Contract #: **04-0120E4**
 Cty **SF** Rte **80** PM **13.4/13.8.**
 File # **45.25 B**

QUALITY ASSURANCE - NONCONFORMANCE REPORT

NCR #125

Subject: Response to Submittal No. 1208, Revision No. 00 (KOS Response to METS NCR 125 (KFM NCR 26))

Below are digital photographs of the discrepancies described above at two locations.

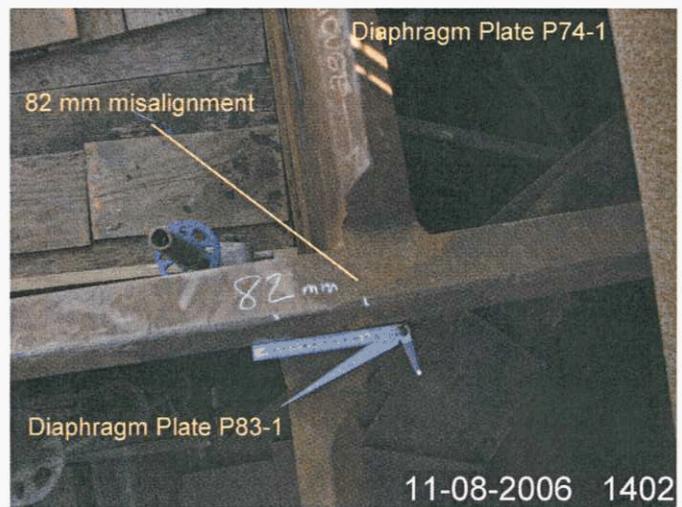
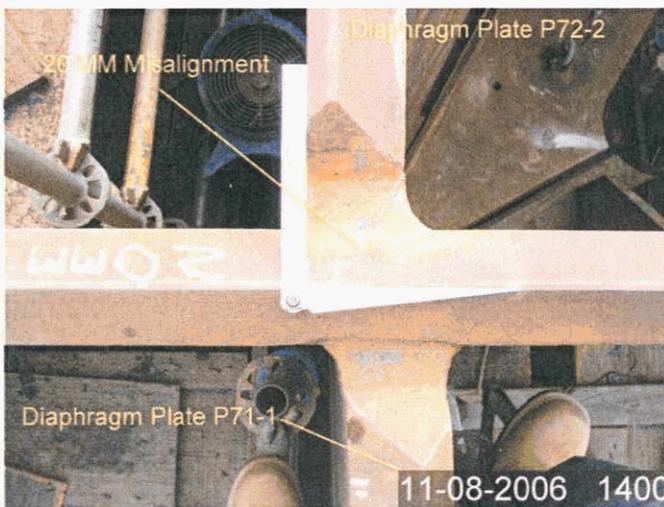
Description of Non-Conformance: KOS Quality Control has allowed the fit-up and welding of misaligned discontinuous diaphragm plates that exceed the five-millimeter maximum as required by the contract Special Provisions. Below are the locations affected:

- Location 1) Diaphragm Plate P71-1 to Diaphragm Plate P72-1 has 20 millimeters of misalignment.
- Location 2) Diaphragm Plate P83-1 to Diaphragm Plate P74-1 has 82 millimeters of misalignment.
- Location 3) Diaphragm Plate P83-2 to Diaphragm Plate P94-2 has 49 millimeters of misalignment.
- Location 4) Diaphragm Plate P91-1 to Diaphragm Plate P92-1 has 23 millimeters of misalignment.

Applicable reference: Special Provisions Section 10-1.31-Shop Welding paragraph H. Dimensional Tolerances, states “Where a discontinuous member provides a continuous load path on either side of a through member, the method of marking and ensuring alignment shall be described in the dimensional control procedure. Misalignment

between discontinuous members shall not exceed 30% of the thickness of the thinner member or 5 mm, whichever is less.”

The Department understands that the Contractor has corrected the misalignment by transitioning the weld on both sides of the discontinuous members at a 2.5 to 1 slope and examined 100% of the weld with ultrasonic examination. The amount of misalignment in the P71/P72-1 connection was verified by the Contractor to be less than 5 mm between the end plate and the base plate, thus per the discussion between the Department and the Contractor of January 11, 2007, additional weld metal in this area is not necessary.

As indicated in the KOS letter dated December 27, 2006, the Contractor has corrected the misalignment by transitioning the weld on both sides of the discontinuous members at a 2.5 to 1 slope and examined 100% of the weld with Ultrasonic Examination (UT) (per State Letter 05.003.01-002440). However, as discussed during the onsite meeting between the Department and the Contractor on January 11, 2007, the Contractor was only required to transition the offset plates for the full height of the web on the P92-1/P91-1 connection. The amount of misalignment in the P71-1/P72-1 connection was verified by the Contractor to be less than 5mm between the end plate and the base plate, thus additional weld metal in this area was not deemed necessary by the Design Team.

1. Diaphragm plate P71-1 to diaphragm plate P72-1 has 20 millimeters of misalignment.
KOS will transition the weld at this location with a 1 on 2.5 transition weld. As stated in State Letter Number 05.003.01-002440

4. Diaphragm plate P91-1 to diaphragm plate P92-1 has 23 millimeters of misalignment.
KOS will transition the weld at this location with a 1 on 2.5 transition weld. As stated in State Letter Number 05.003.01-002440

Below are digital photographs of the discrepancies described above.

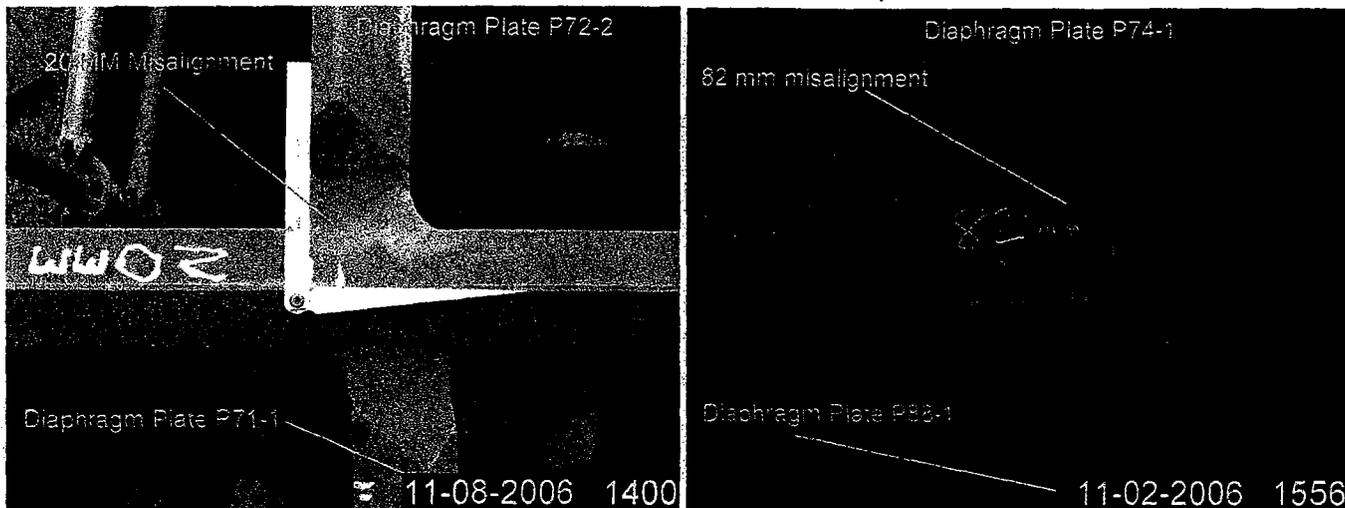
Description of Non-Conformance: KOS Quality Control has allowed the fit-up and welding of misaligned discontinuous diaphragm plates that exceed the five-millimeter maximum as required by the contract Special provisions. Below are the locations affected:

Location 1) Diaphragm Plate P71-1 to Diaphragm Plate P72-1 has 20 millimeters of misalignment.

Location 2) Diaphragm Plate P88-1 to Diaphragm Plate P74-1 has 82 millimeters of misalignment.

Location 3) Diaphragm Plate P88-1 to Diaphragm Plate P94-2 has 49 millimeters of misalignment.

Location 4) Diaphragm Plate P91-1 to Diaphragm Plate P92-1 has 23 millimeters of misalignment.

Applicable reference: Shop welding section, in the Special Provisions, paragraph H. Dimensional Tolerances, states “Where a discontinuous member provides a continuous load path on either side of a through member, the method of marking and ensuring alignment shall be described in the dimensional control procedure. Misalignment between discontinuous members shall not exceed 30% of the thickness of the thinner member or 5 mm, whichever is less.”

Below are digital photographs of the discrepancies described above at two locations.

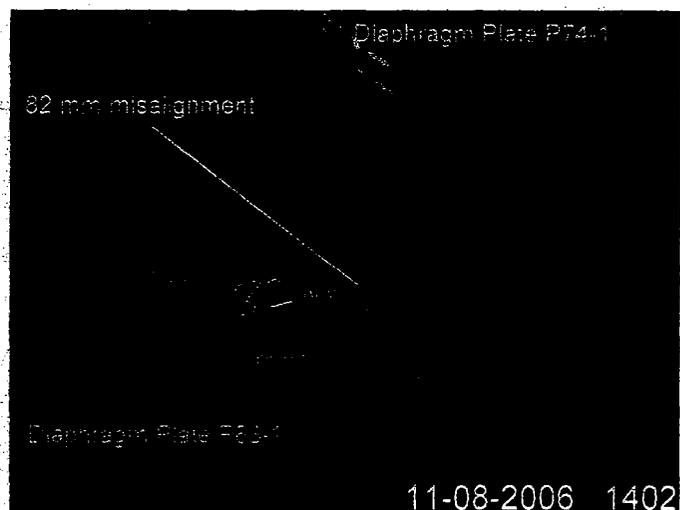
Description of Non-Conformance: KOS Quality Control has allowed the fit-up and welding of misaligned discontinuous diaphragm plates that exceed the five-millimeter maximum as required by the contract Special Provisions. Below are the locations affected:

Location 1) Diaphragm Plate P71-1 to Diaphragm Plate P72-1 has 20 millimeters of misalignment.
 Location 2) Diaphragm Plate P83-1 to Diaphragm Plate P74-1 has 82 millimeters of misalignment.
 Location 3) Diaphragm Plate P83-2 to Diaphragm Plate P94-2 has 49 millimeters of misalignment.
 Location 4) Diaphragm Plate P91-1 to Diaphragm Plate P92-1 has 23 millimeters of misalignment.

Applicable reference: Special Provisions Section 10-1.31-Shop Welding paragraph H. Dimensional Tolerances, states "Where a discontinuous member provides a continuous load path on either side of a through member, the method of marking and ensuring alignment shall be described in the dimensional control procedure. Misalignment

between discontinuous members shall not exceed 30% of the thickness of the thinner member or 5 mm, whichever is less.”
